**CITY OF ISSAQUAH
DEVELOPMENT SERVICES DEPARTMENT
ADMINISTRATIVE REVIEW**

NOTICE OF DECISION

SUBJECT: Capelouto Short Plat

APPLICATIONS: SP14-00001 (Short Plat)
ASDP14-00006 (Administrative Site Development Permit)
AAS14-00004 (Administrative Adjustment of Standards: Setbacks)

PROJECT#: 13-400 SHEET: 2 OF 2

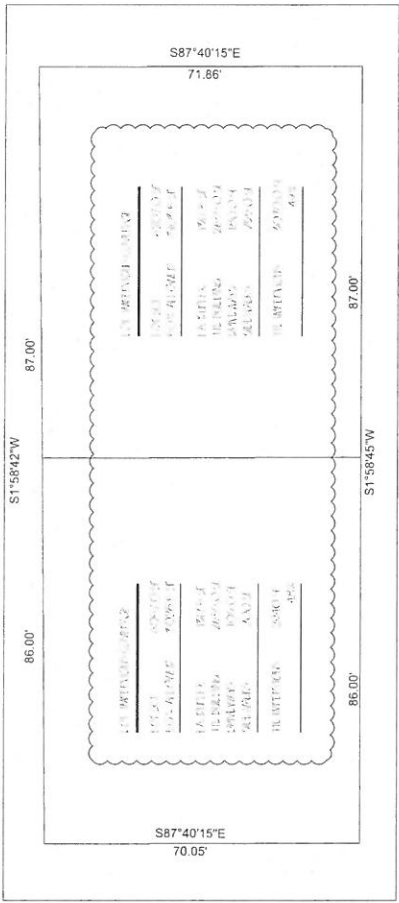
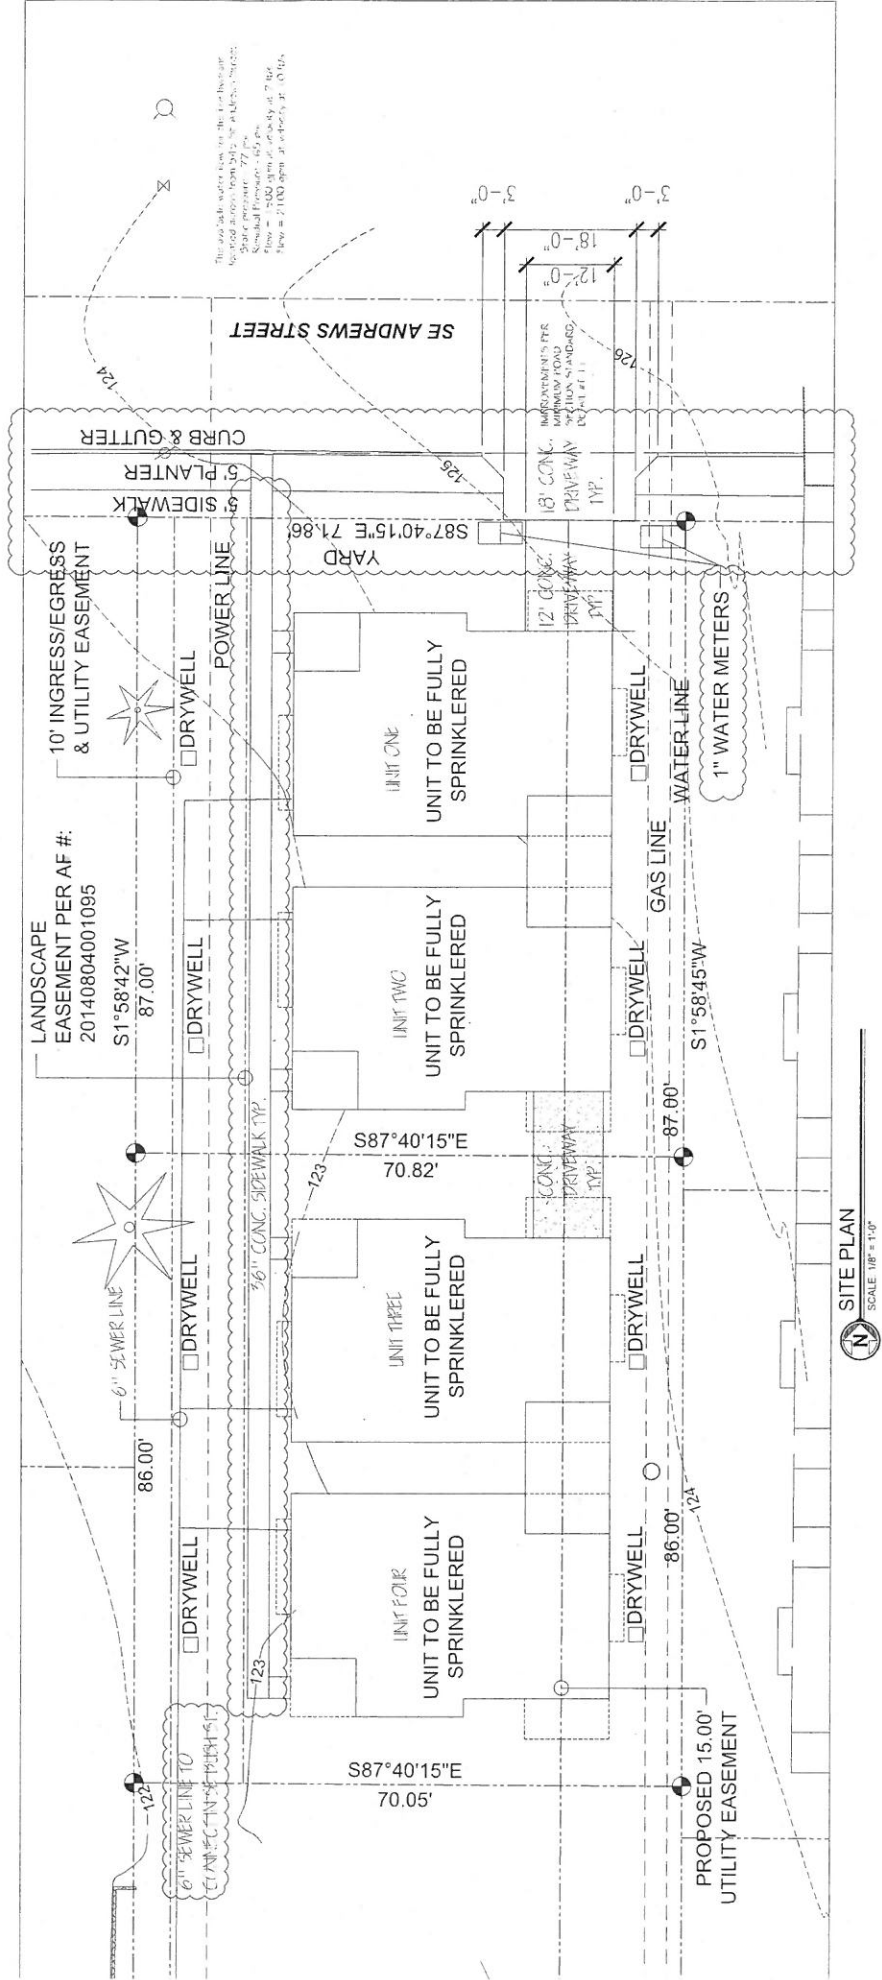
2. Correct the record number in the Survey Note on Sheet 1 to show 20130905900007. The record number shown on the proposed plat is incorrect.
3. The Planning file number shall be placed on both mylar sheets. The short plat file number is: SP14-00006.

SITE PLAN
SCALE: 1/8" = 1'-0"

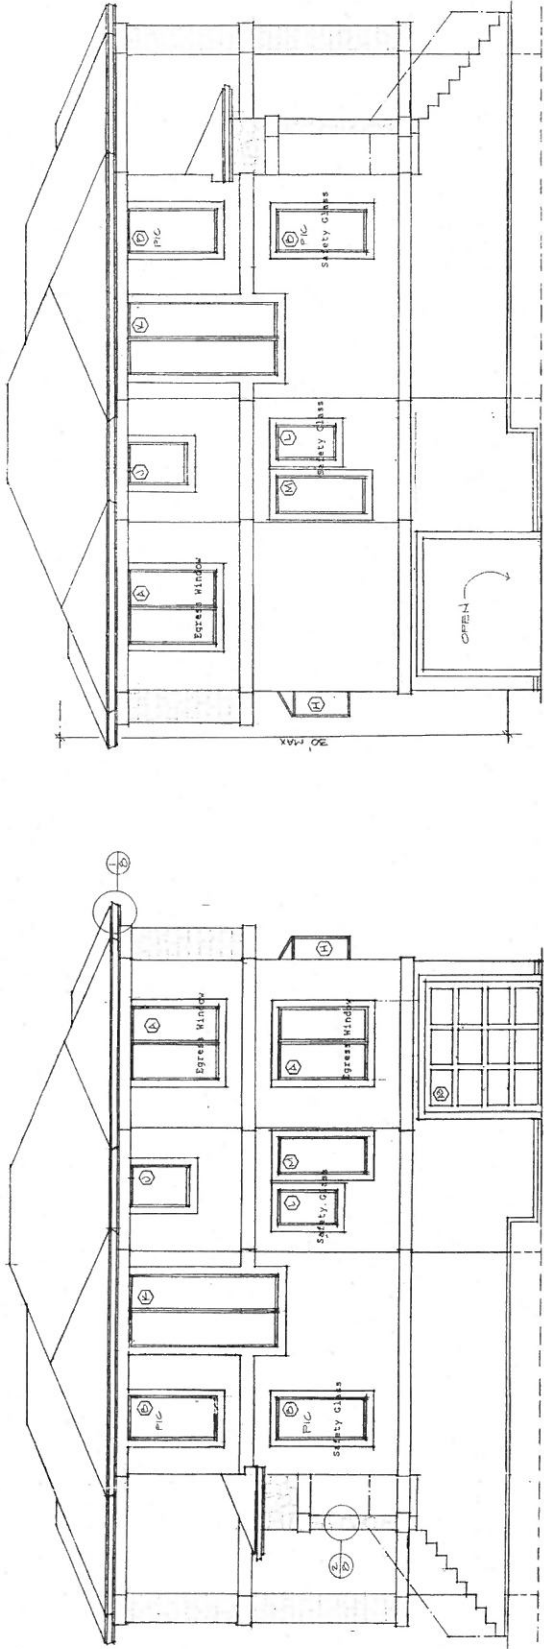
13. The proposed site plan does not show the sewer connection for Lots A and B through Lot C to SE Bush St. The sewer line connection to SE Bush shall be shown on the Site Work Permit to include any portion of work on Lot C per the City's Sewer Standards.

14. The main building walkway shall terminate at the beginning of right of way, specifically the sidewalk and not the curb, as shown in the site plan.

22. Utility appurtenance locations that were not shown in the site plan are not approved at this time and if visible from the street shall require screening.

ELEVATIONS / SECTIONS

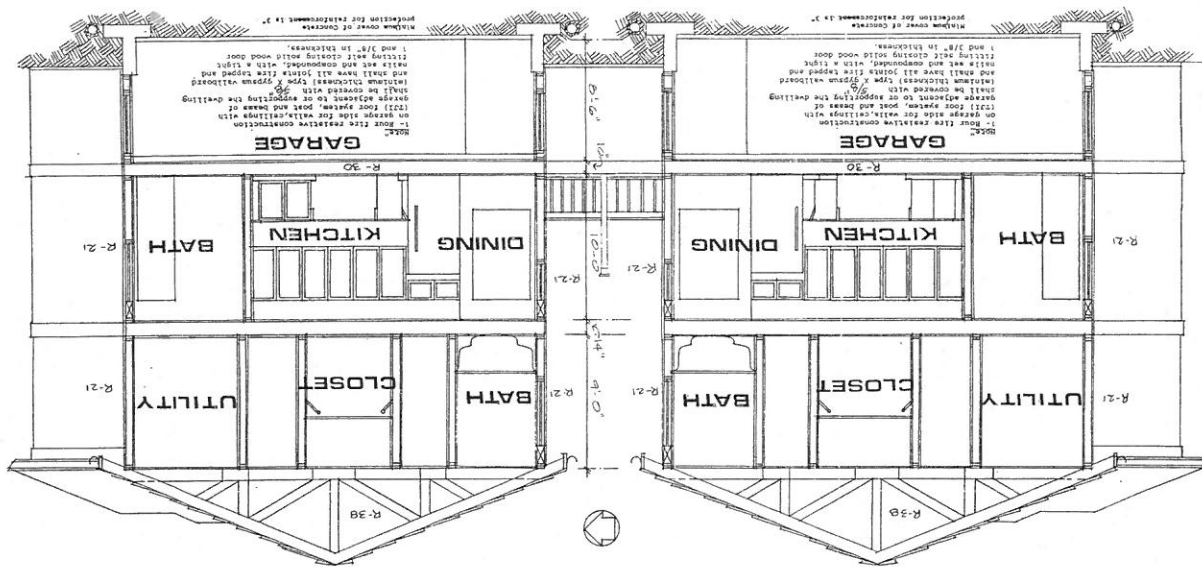
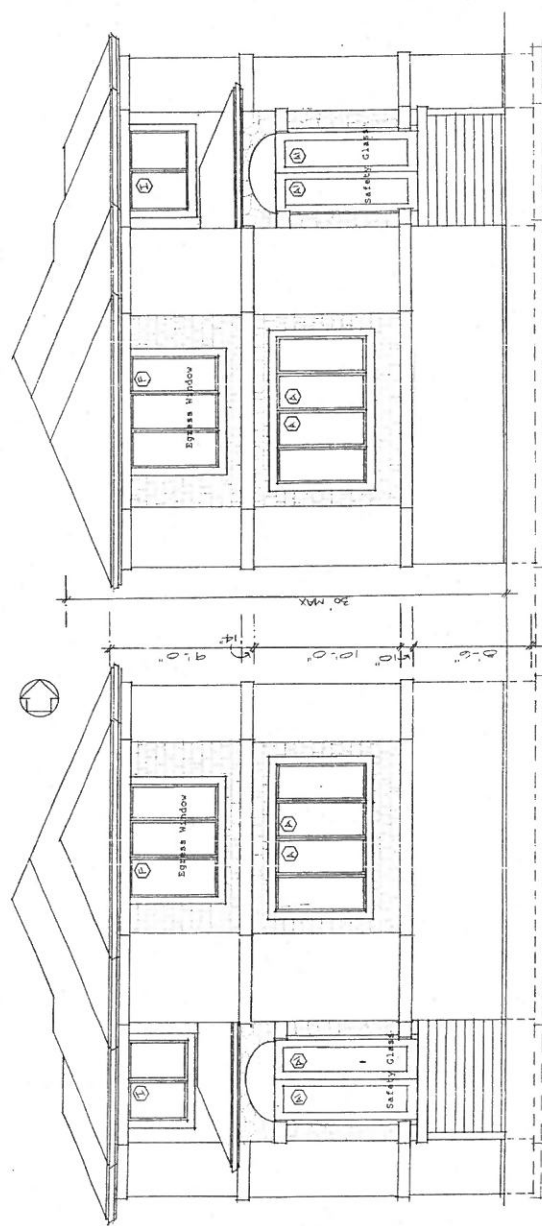
adequately screen the blank wall on the north elevation closest to the street of the duplex on Lot A. Modulation or some similar treatment is required for the blank wall as required by IMC 18.12.135 Additional landscape requirements for blank walls abutting public right-of-way. If landscaping is going to be used to screen the blank wall, it shall be located adjacent to the blank wall, provide coverage to the entire first level blank wall, and provide year round coverage through the use of evergreen trees and plants.
